From: Bredin, Dana <Dana.Bredin@wsp.com>
Sent: April-01-19 4:16 PM
To: Dey, Asit (SD)
Cc: mdumaine@ritchot.com; Suresh, Nada (SD); Boswick, Robert (SD); Burland Ross, Siobhan (SD); Bunn, Jason; Webster, Ross; Goss, Charles
Subject: RE: 2019-03-29__Additional Information Request_St. Adolphe WWTL_RM of Ritchot_File 2633.10
Attachments: St Adolphe Lagoon - Truck Dump - CL103.pdf

From: Dey, Asit (SD) <Asit.Dey@gov.mb.ca>
Sent: March-29-19 2:38 PM
To: Goss, Charles <Charles.Goss@wsp.com>; Bredin, Dana <Dana.Bredin@wsp.com>
Cc: mdumaine@ritchot.com; Suresh, Nada (SD) <Nada.Suresh@gov.mb.ca>; Boswick, Robert (SD) <Robert.Boswick@gov.mb.ca>; Burland Ross, Siobhan (SD) <Siobhan.BurlandRoss@gov.mb.ca>
Subject: 2019-03-29__Additional Information Request_St. Adolphe WWTL_RM of Ritchot_File 2633.10

PROJECT: ST. ADOLPHE LAGOON PROPOSED ACCESS ROAD AND TRUCK DUMP RAMP

TITLE: ST. ADOLPHE LAGOON SECTION VIEWS

SHEET NUMBER: C103
SHEET #: 3 OF 3
ISSUE: ISSUED FOR APPROVAL
DATE OF: 2019/04/01

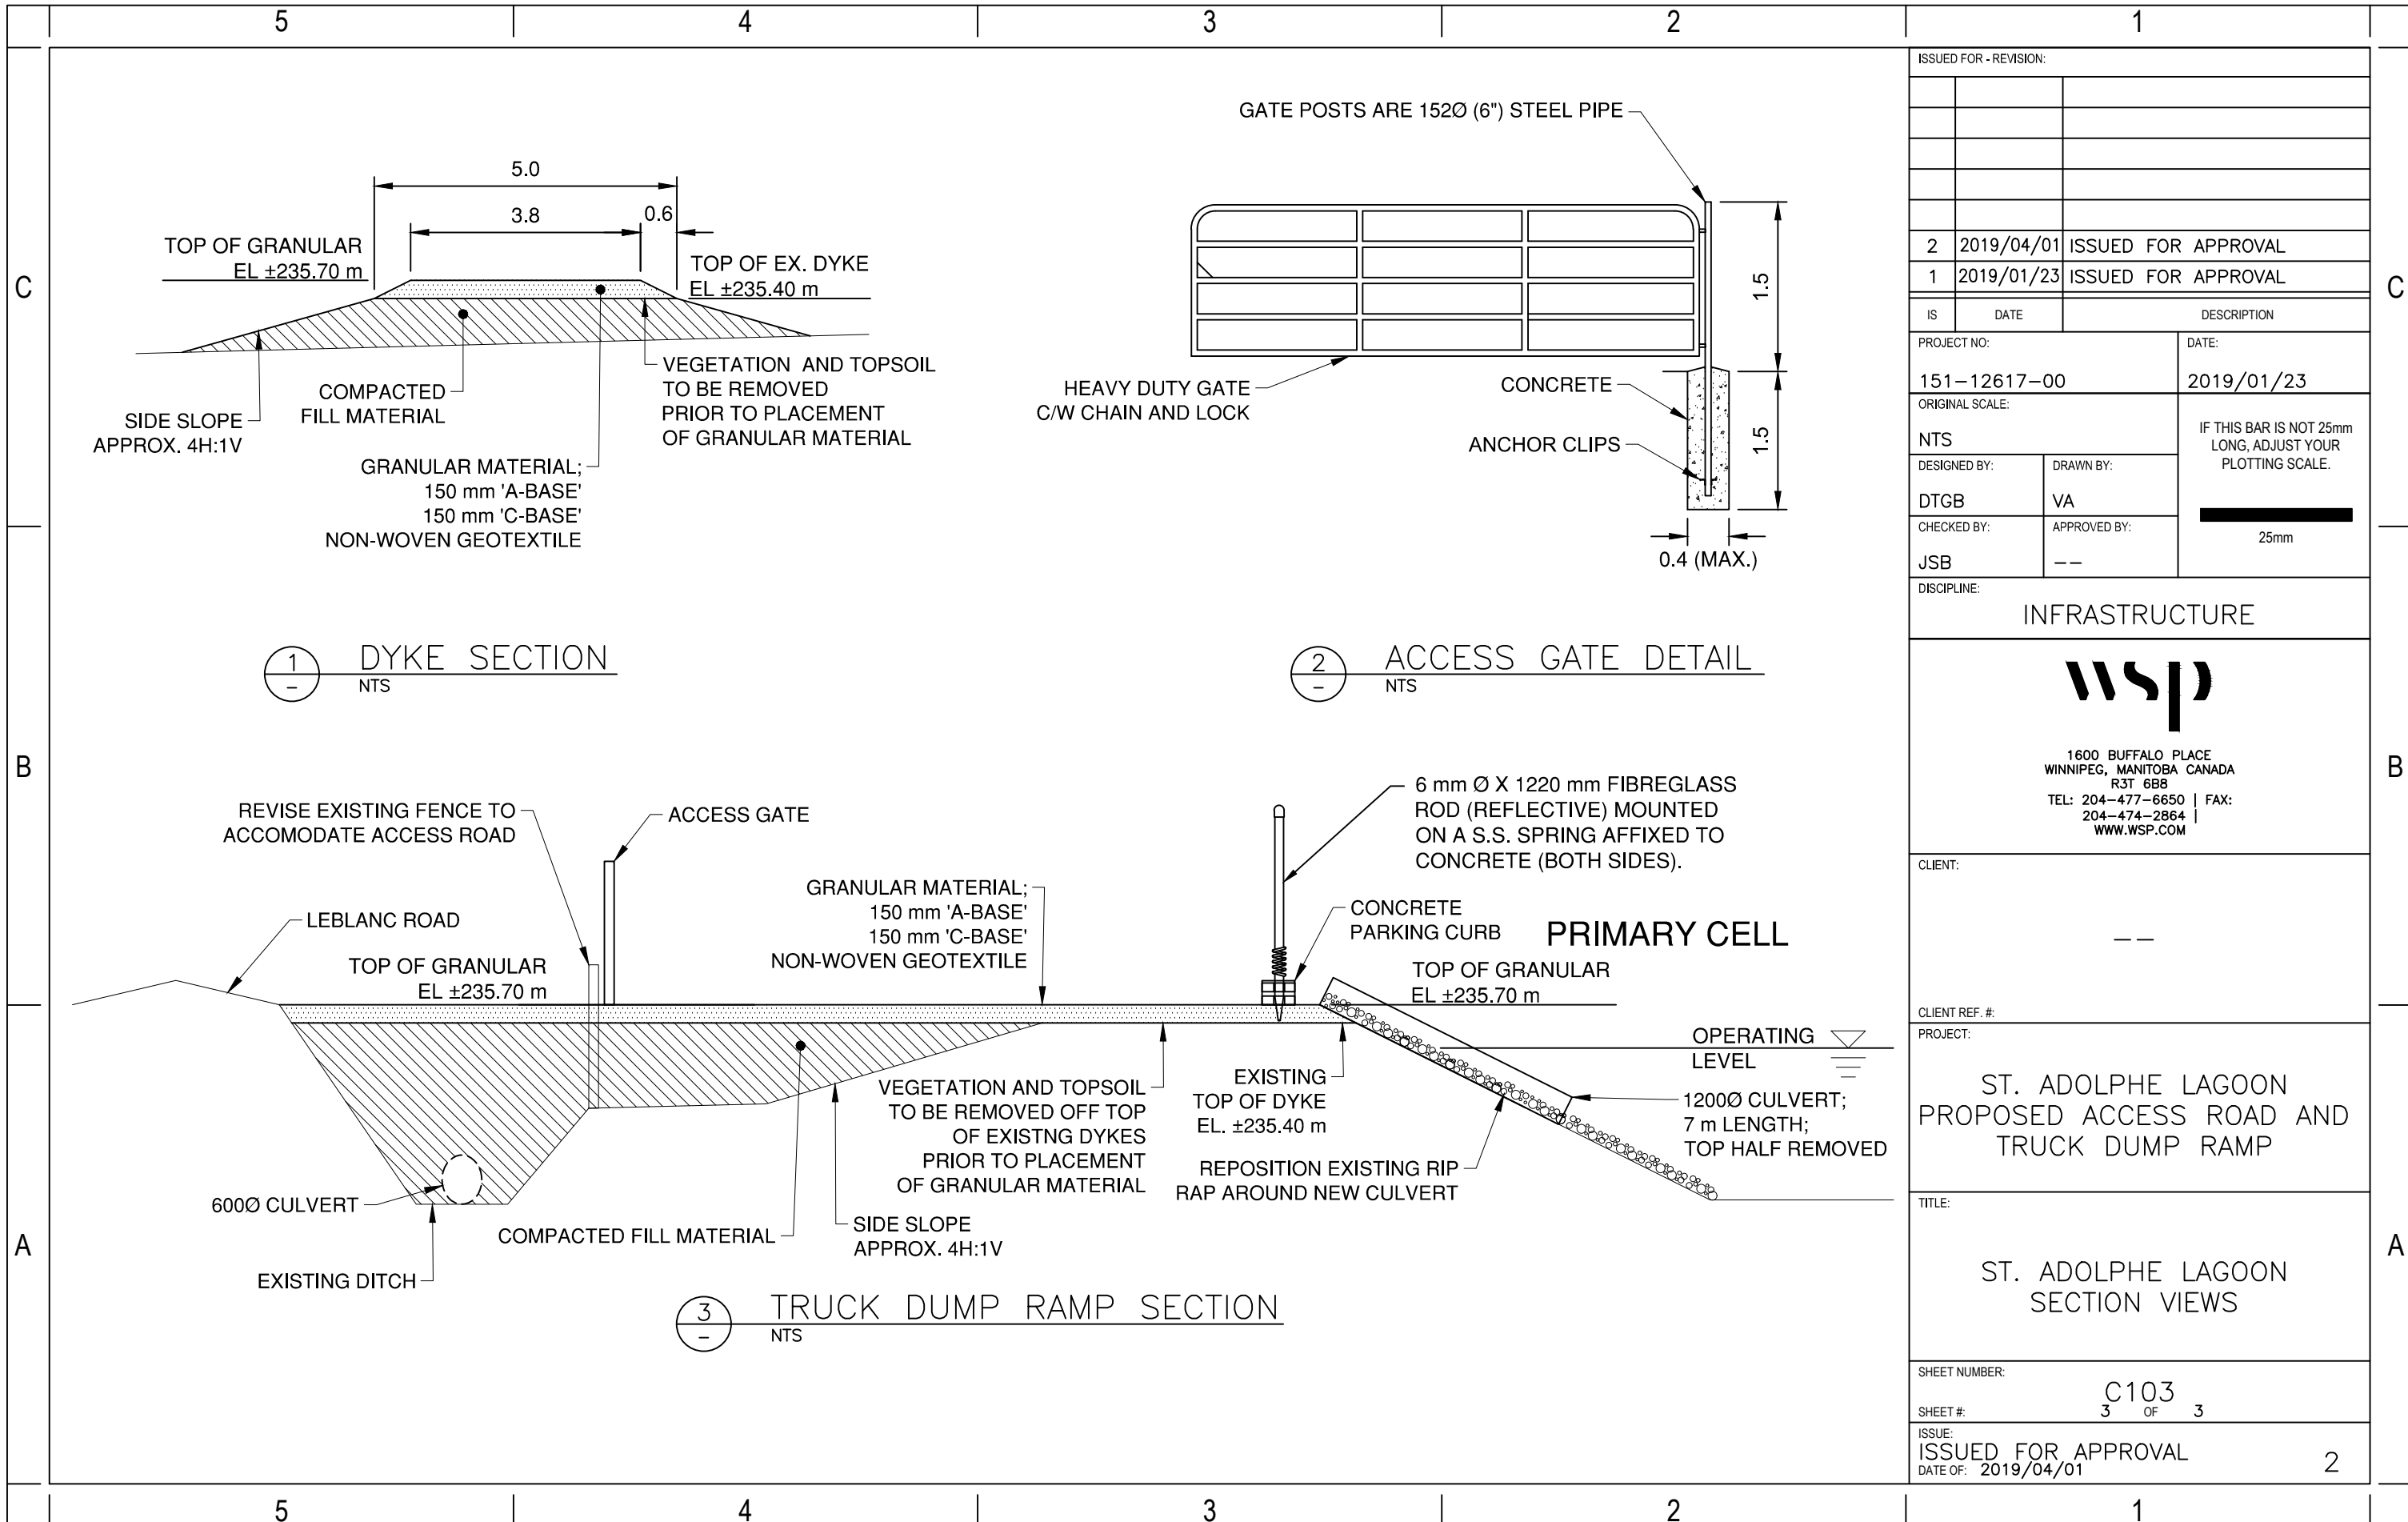
Good afternoon. This email is in follow up to my previous email dated October 1, 2018. Receipt of your submissions dated February 1, 2019 is hereby acknowledged. Could you please advise us if you are considering including bollards in the design of the truck dumping station. It is our understanding that incorporation of bollards in the design of truck dumping station is a common practice for effective and safe disposal of truck hauled wastewater.

- Access road construction method along with access road profile with elevation;
- Truck dump station construction method along with engineering drawing(s) on truck dump station details;
- Please comment on whether the vehicular traffic is going to compromise the structural integrity of the existing south dyke of the secondary cell; and
- Please also indicate how many trucks that the lagoon can accommodate such that the lagoon's daily organic loading capacity will not be compromised.

I've attached a revised drawing CL103, which details the addition of a reflective fibreglass rod on a stainless steel spring affixed to the concrete curb on both sides. This is the preferred option by the RM of Ritchot as opposed to a fixed bollard.
